Mayberry Phase 1
Amendment to the Ellicott Town Center
Phase 1 PUD/Preliminary Plan
Transportation Memorandum
PCD FILE NO.: PUDSP219
(LSC #S214300)
October 22, 2021

Mayberry Phase 1 PUD Amendment Transportation Memorandum

RE: Mayberry Phase 1
Amendment to the Ellicott Town
Center Phase 1 PUD/Preliminary Plan
El Paso County, CO
Transportation Memorandum
EPC PCD File No.: PUDSP219
LSC #S214300

(VILLAGE MAIN STREET) TYPICAL COMMERCIAL SECTION

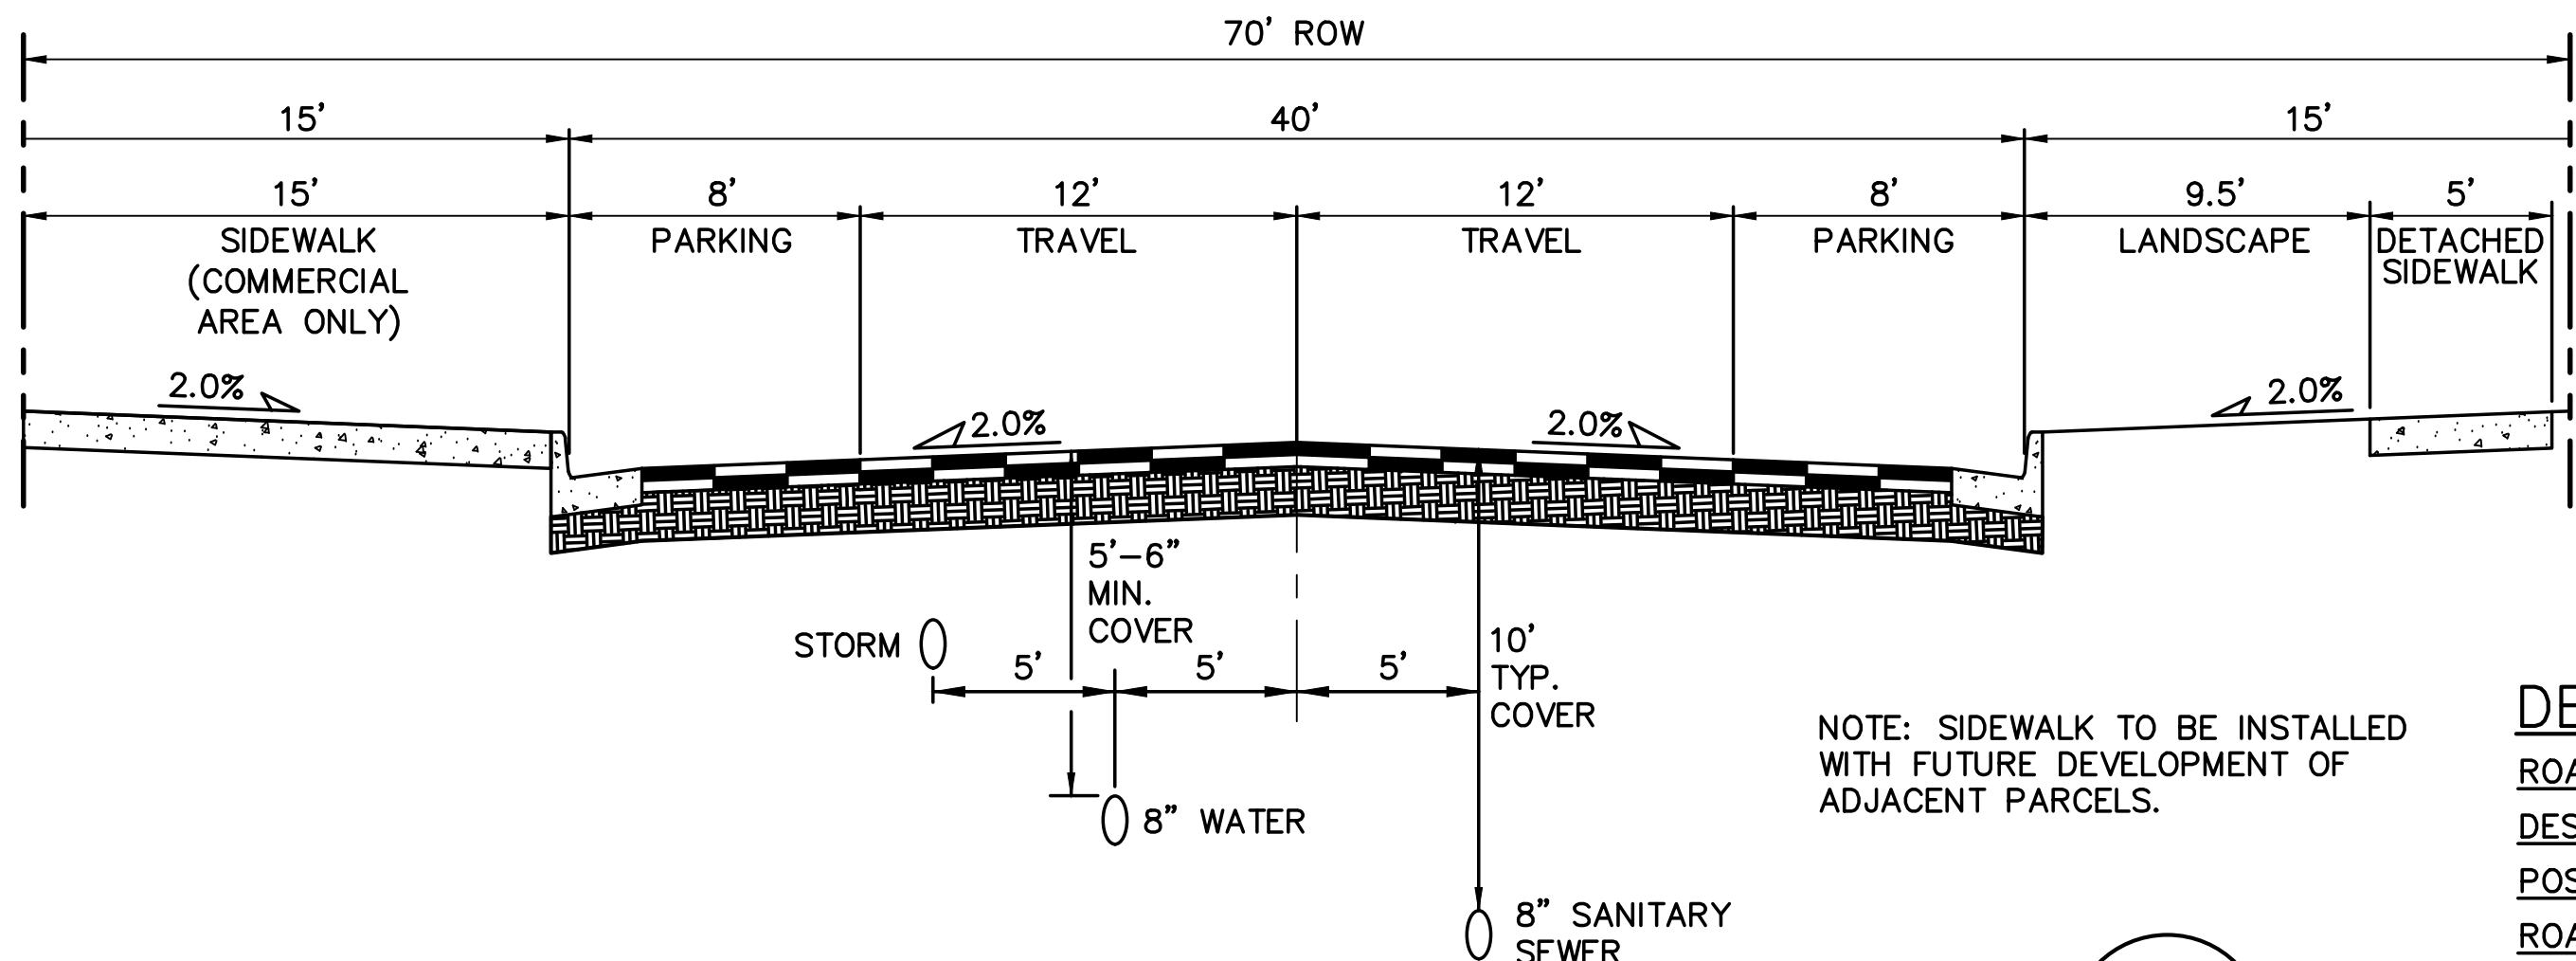
Please explain the reasoning for the classification of the southerly portion of this road to urban local. Springs road is the main access for the commercial developments to eventually go west at New Log Rd. The wider pavement section of a collector road may be needed for the commercial traffic that will utilize this roadway. Per the PUD development plan submitted it appears that only the ROW width is changing from 65' to 60' but the paved width is staying the same. Please clarify if the only change proposed in terms of the roadway cross section is the ROW width. Please be aware that design attributes of this roadway will be required to meet Collector standards.

SHEET: C2.1

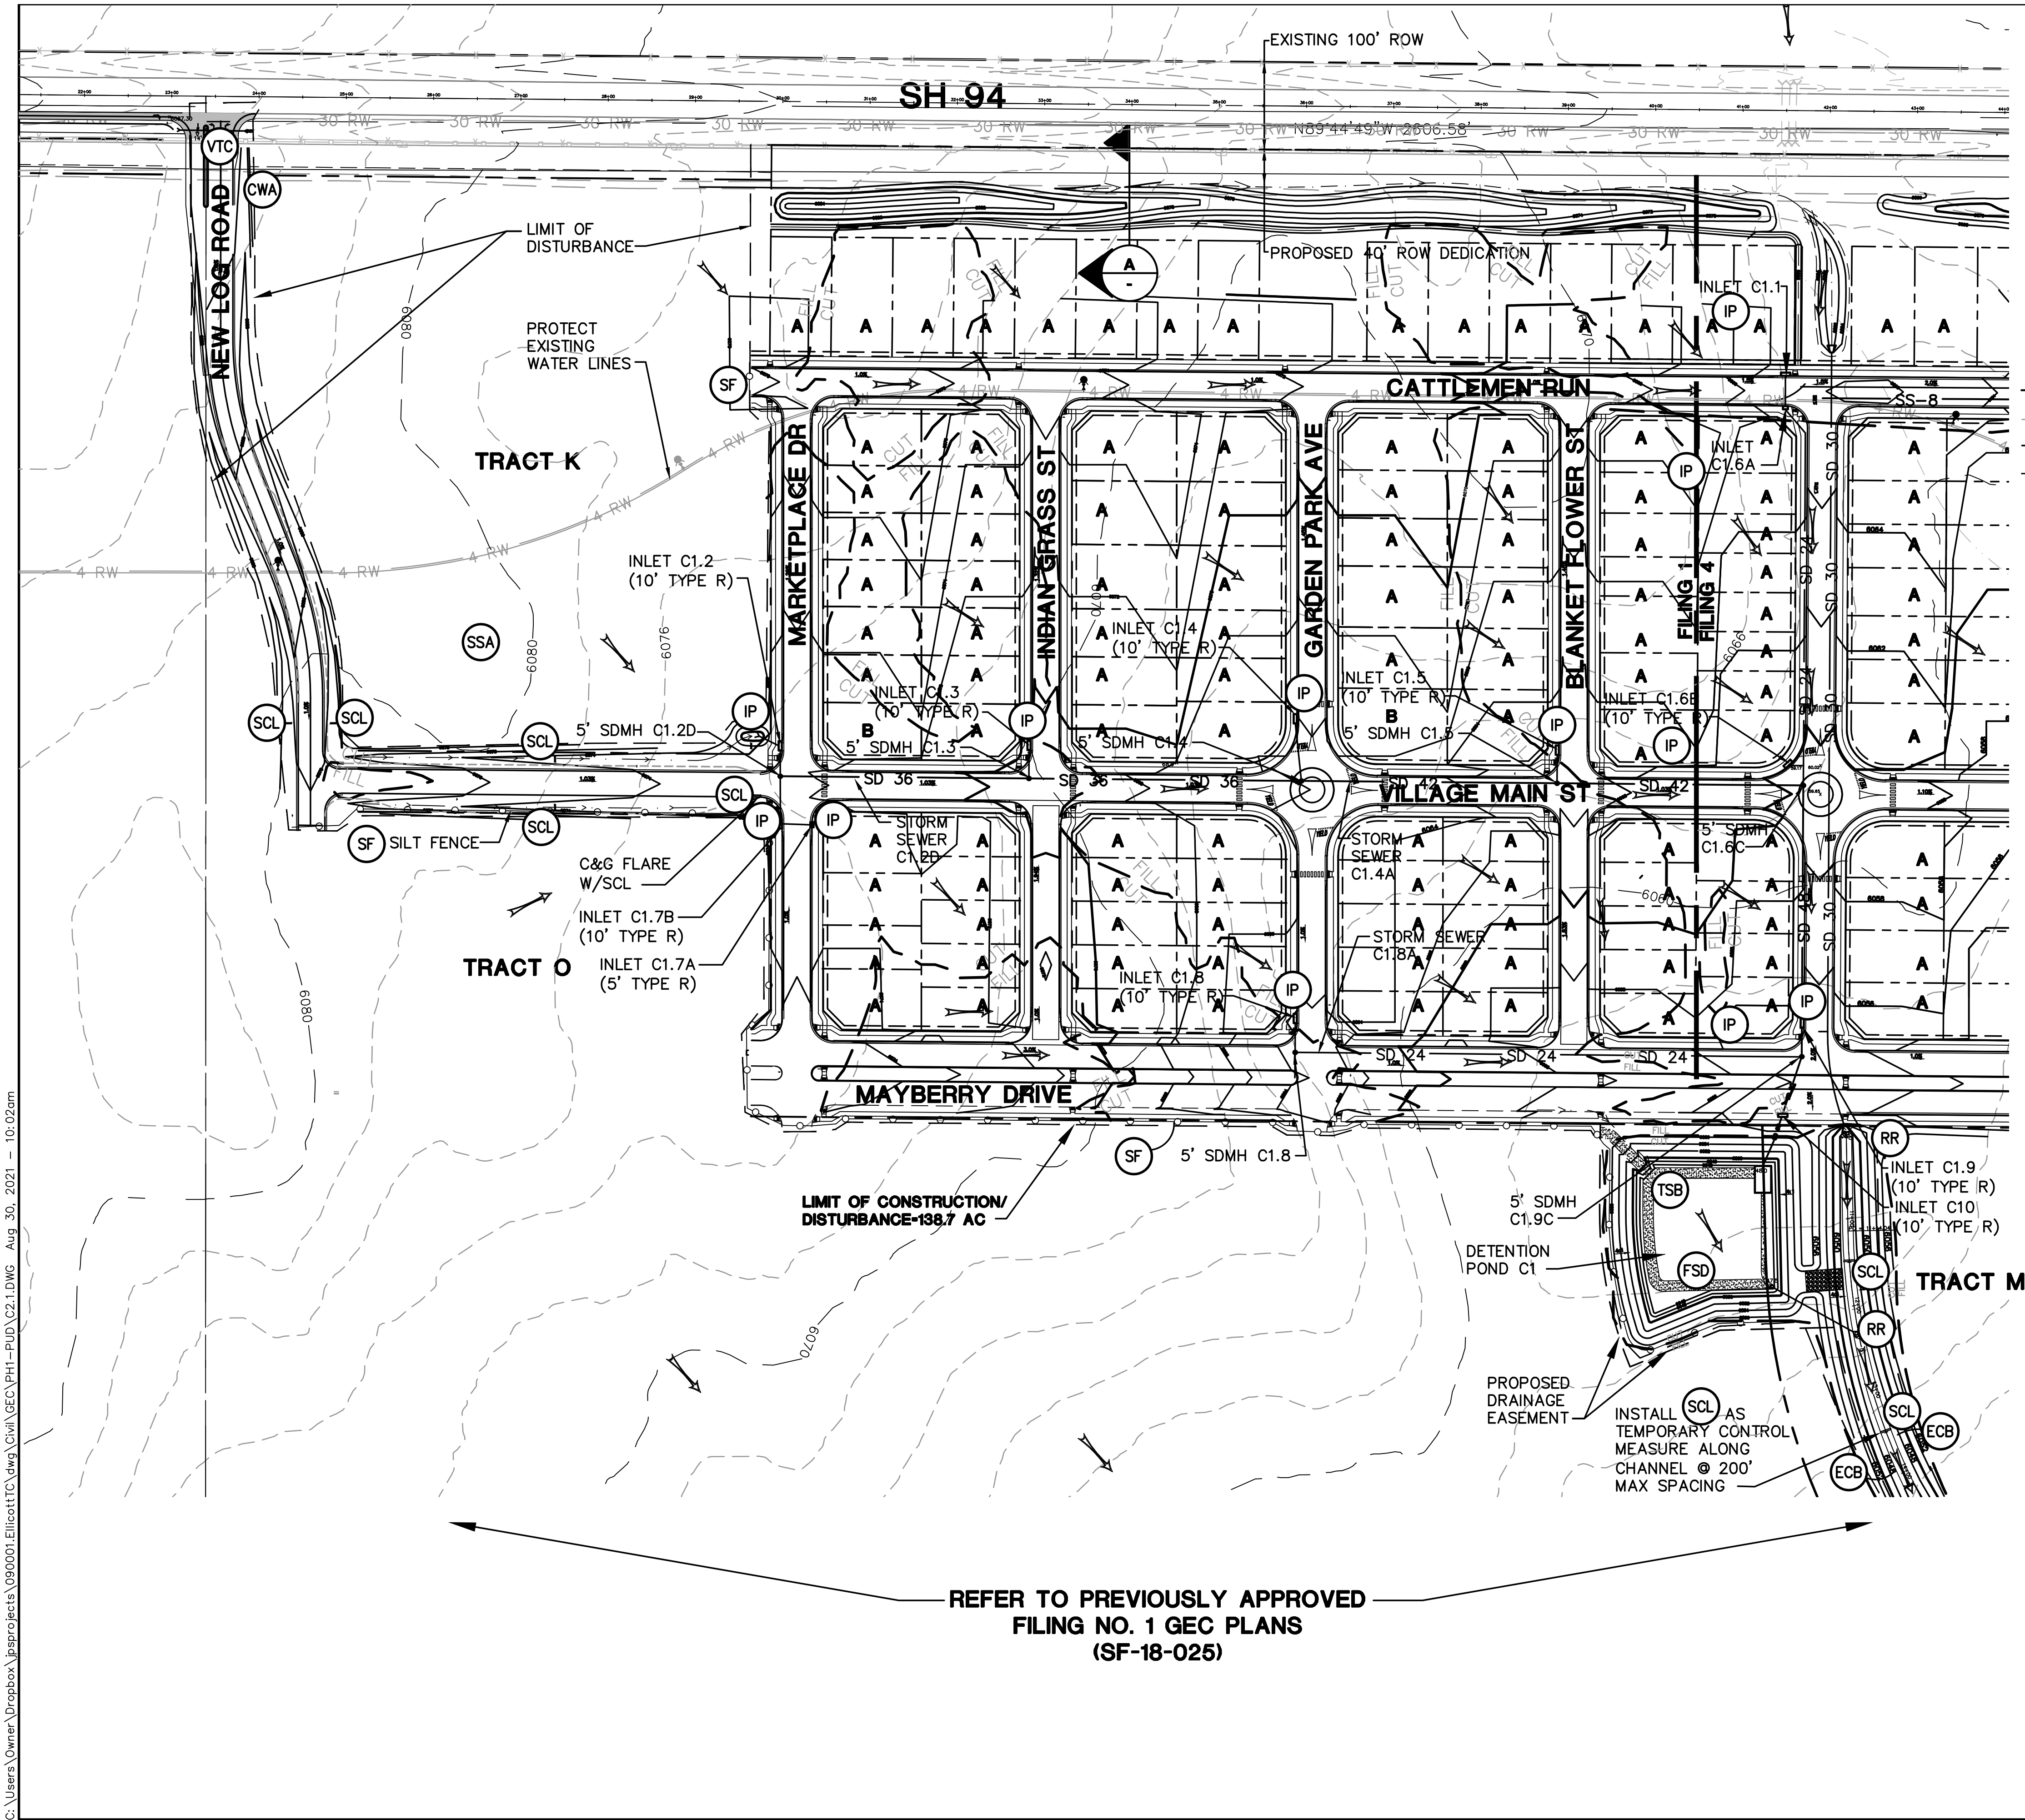
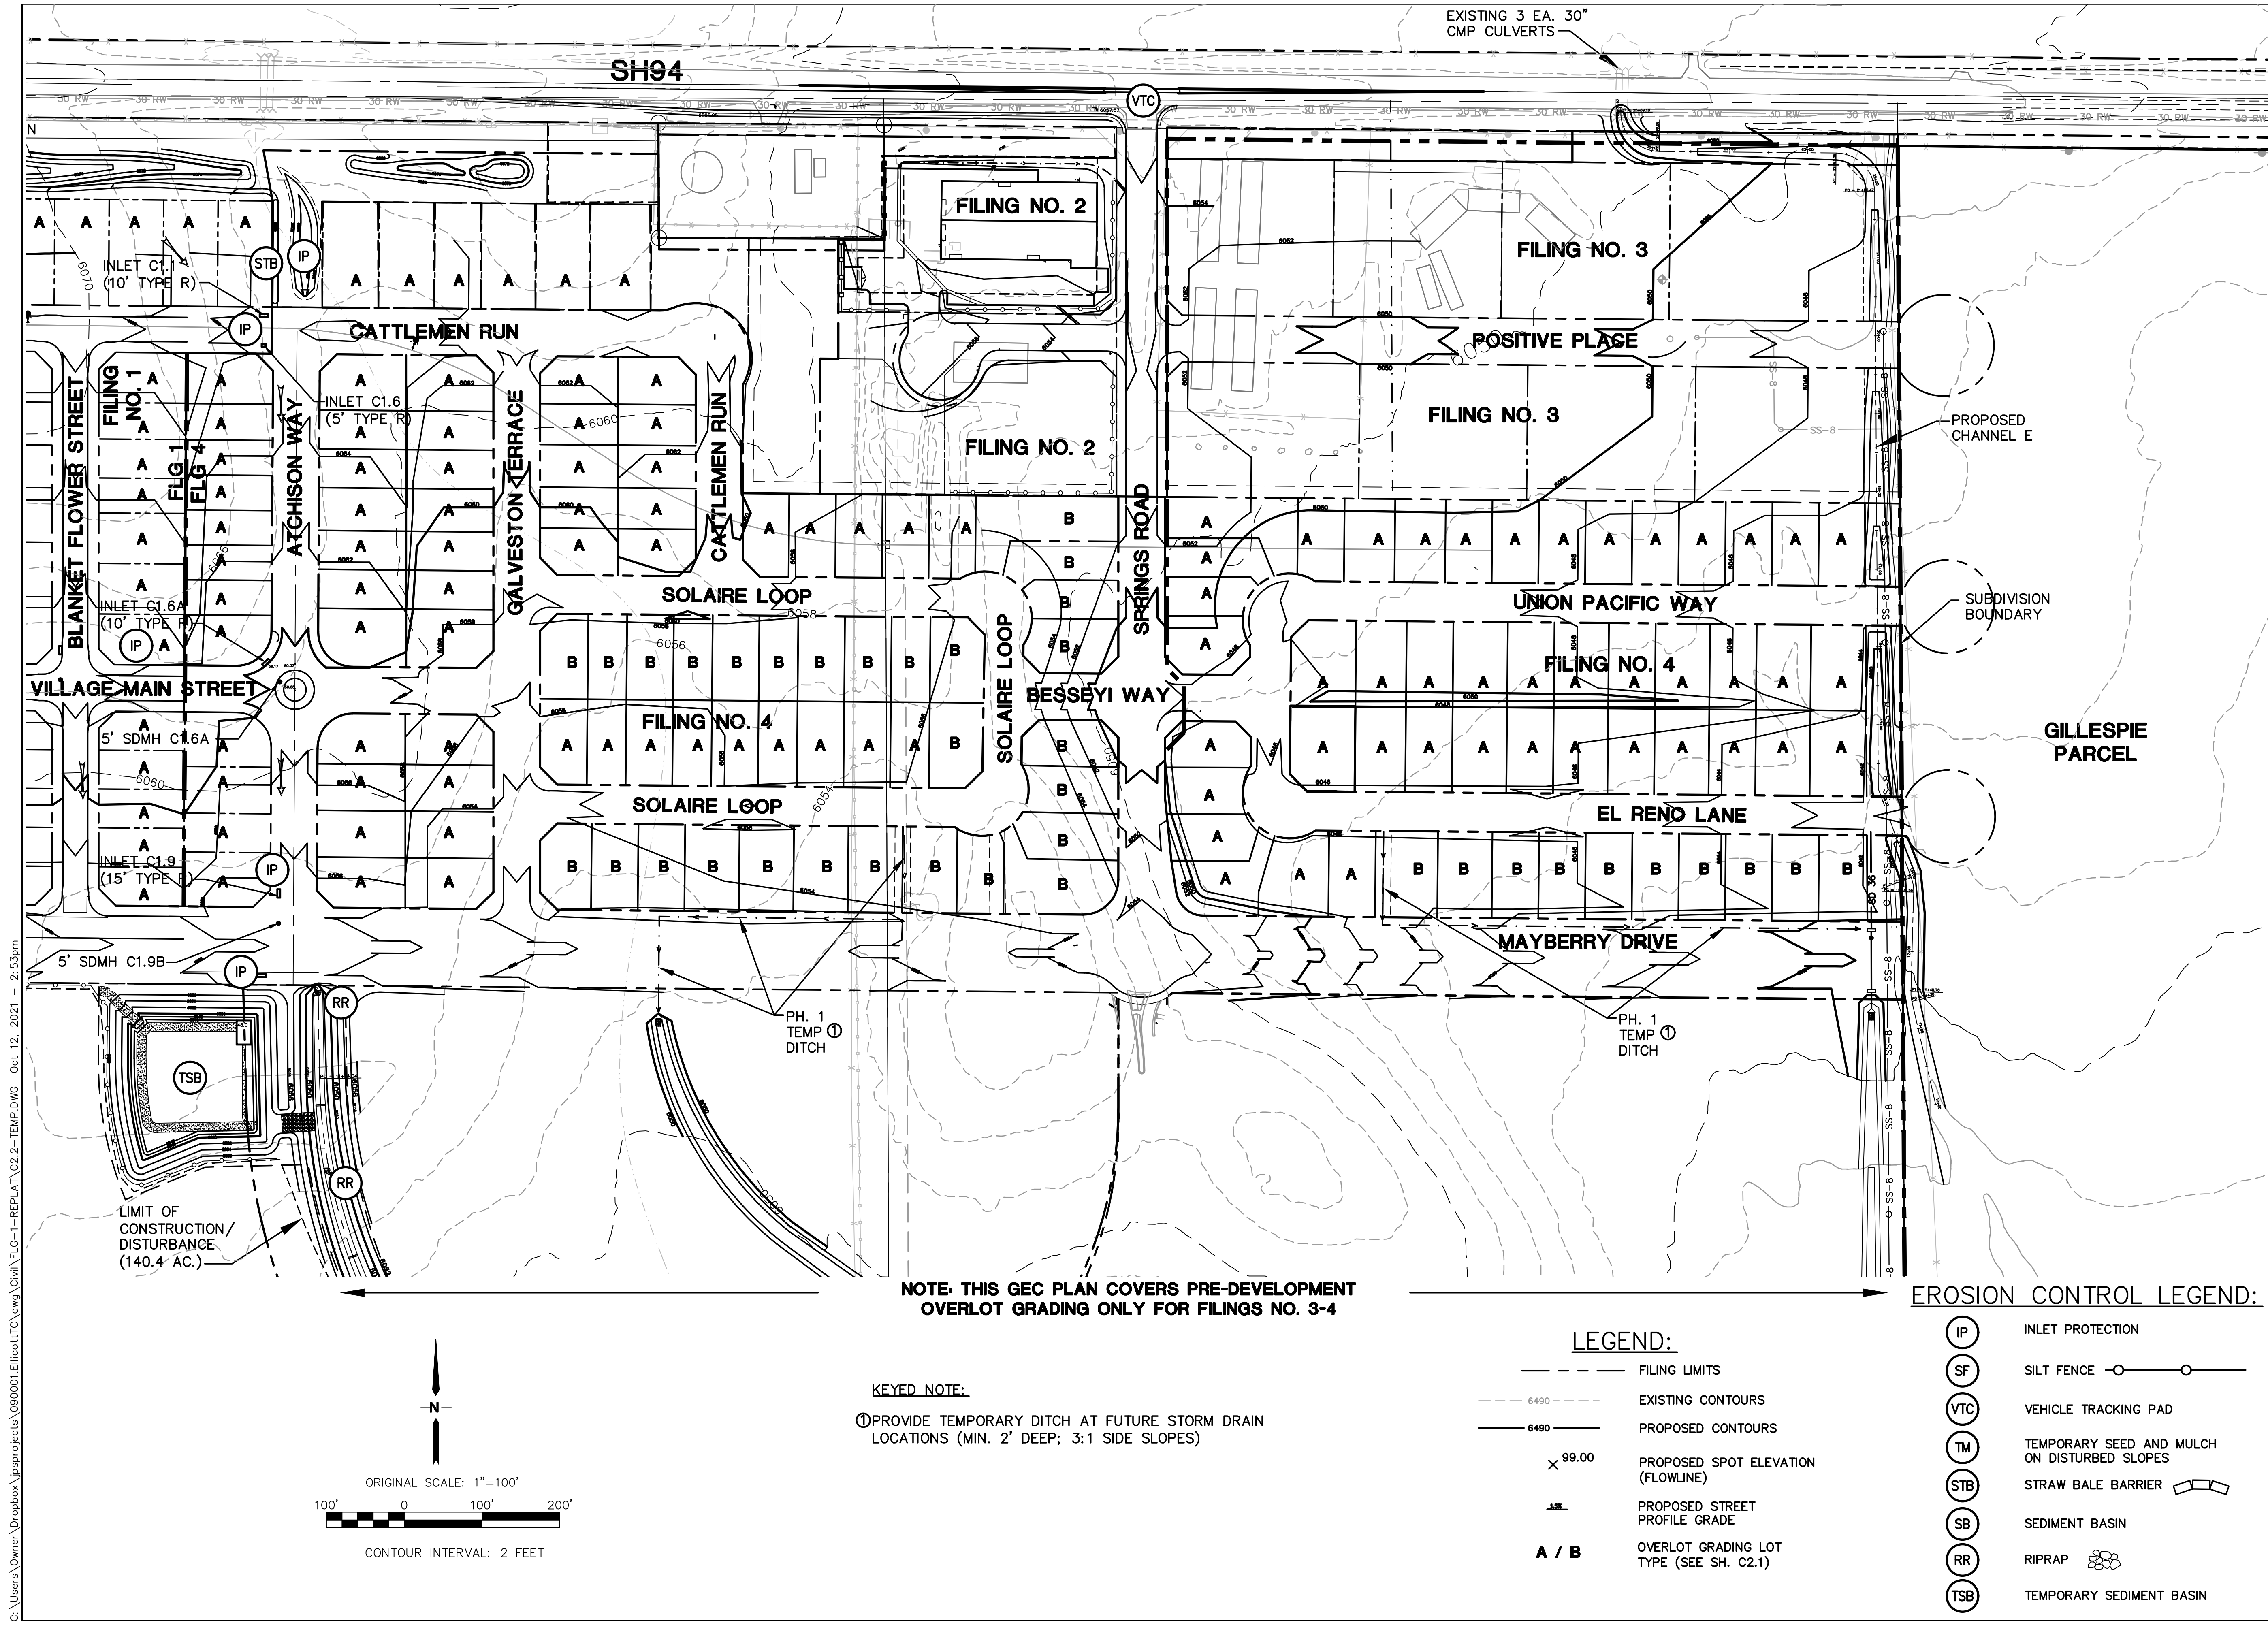
Please coordinate with the civil engineer and planner as the pre-development grading plan proposed with this application shows overlaid grading of lots and rough cut of the roadways of Filing 4 such that Village Main does not connect to Springs road.
